Replacement of 8DB 355 013-221 (WVA 24529) with 8DB 355 023-401 (WVA 25087).

Hella Pagid aims to streamline the designation from 8DB 355 013-221 to 8DB 355 023-401.

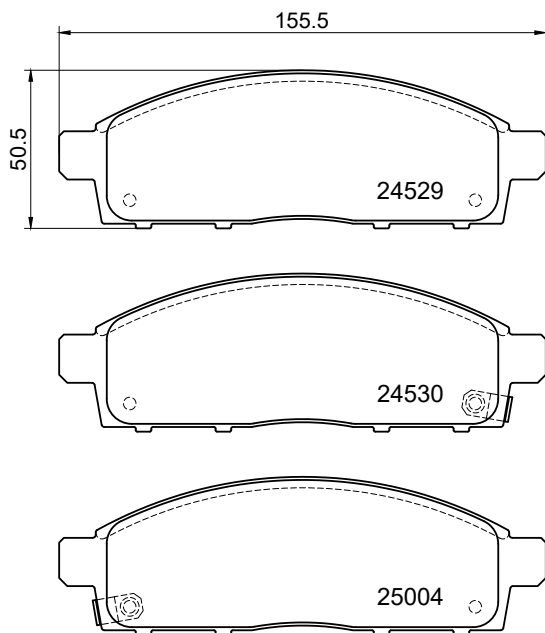
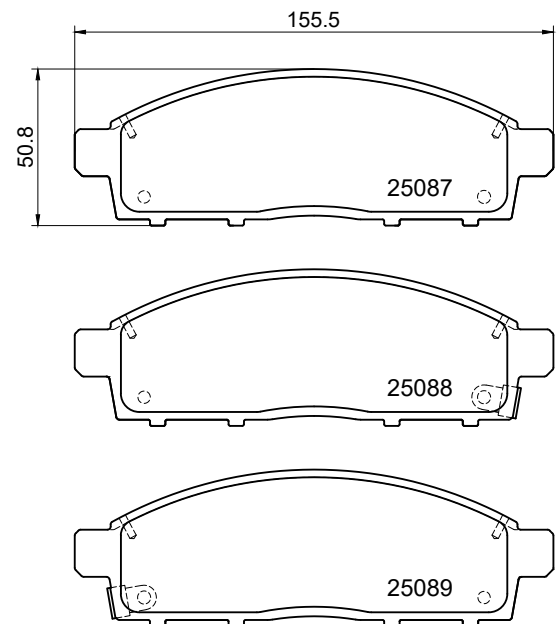
Given the identical nature of the brake pads we can ensure seamless assembly and operation.

This consolidation extends coverage to a broader range of vehicles under a singular reference, namely 8DB 355 023-401 which comes with drill holes in the plate and therefore is able to cover applications of both part numbers.

The current inventory of 8DB 355 013-221 can be effortlessly marketed and sold without any complications.
